Steven M. Clouse Water Recycling Center Perimeter Fence
Solicitation Number: B-19-017-AT
Job No.: 19-0132

ADDENDUM 3
September 10, 2019

Fence Location (not to Scale)

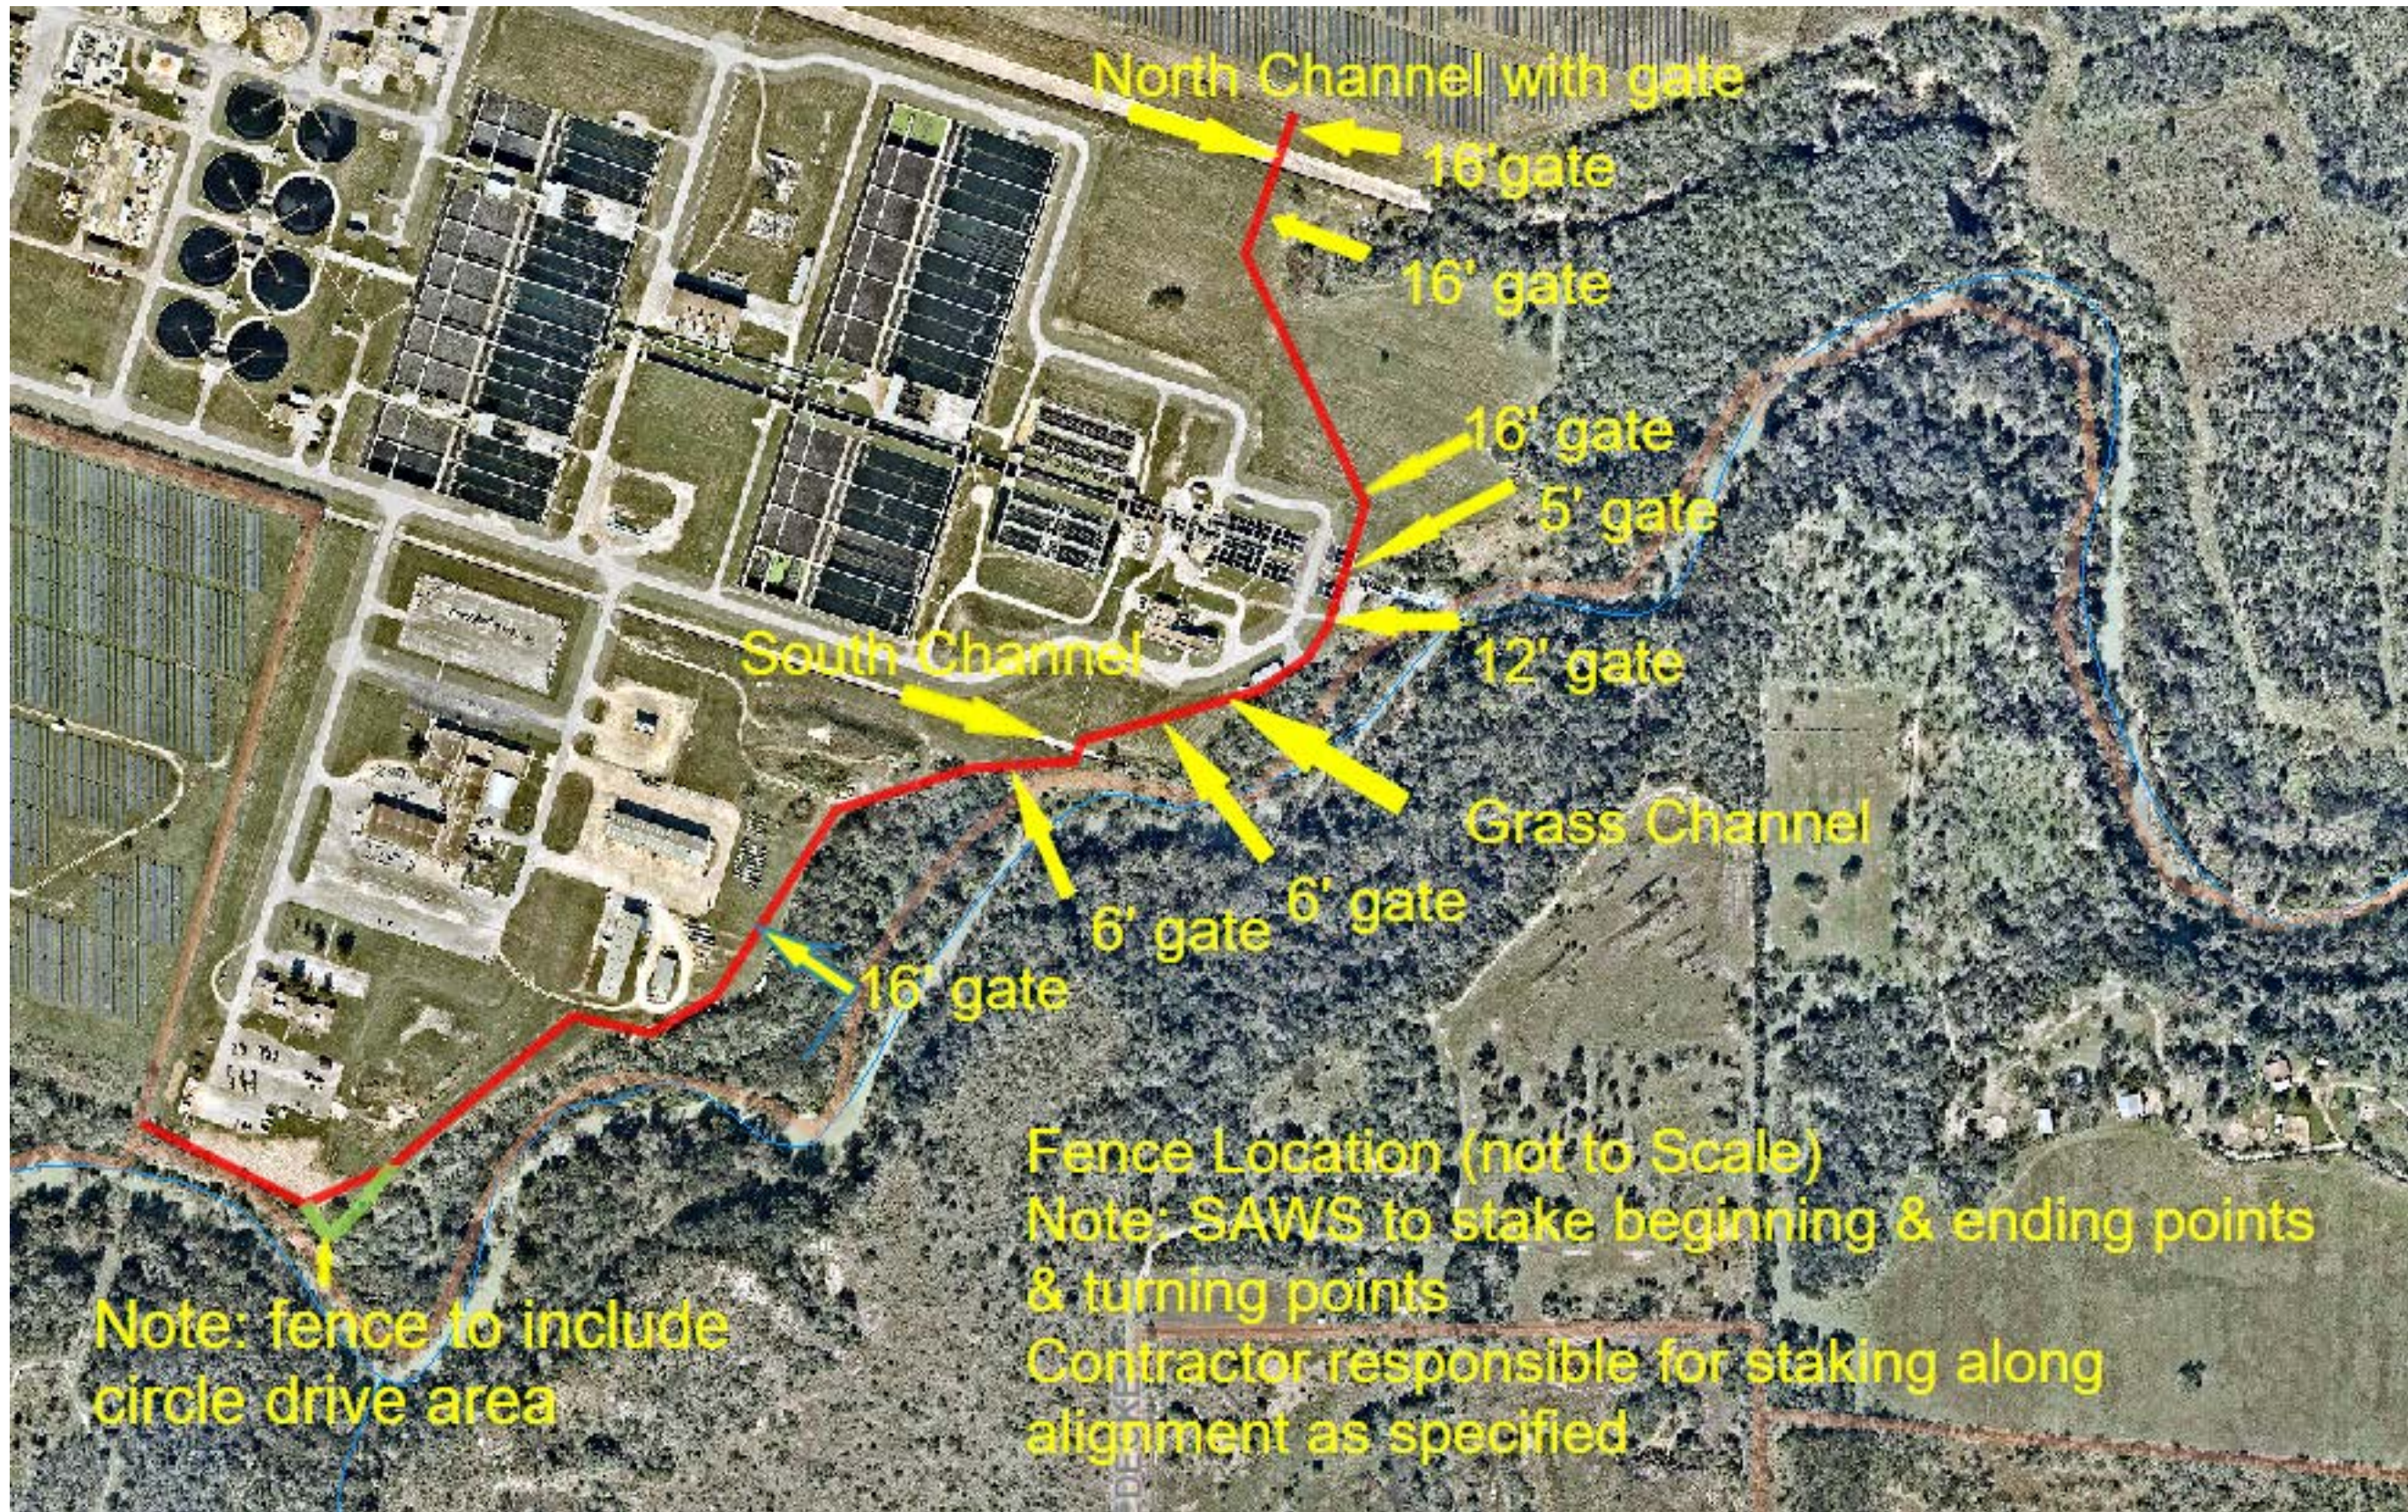
1. Delete page 143 of the solicitation and replace with the attached revised aerial view of the Steven M. Clouse Water Recycling Center included in this Addendum.

1. The Changes to the Specifications listed above have been made to provide a more accurate aerial view of the Steven M. Clouse Water Recycling Center.

Note: SAWS to stake beginning & ending points & turning points

Contractor responsible for staking along alignment as specified

Note: fence to include circle drive area
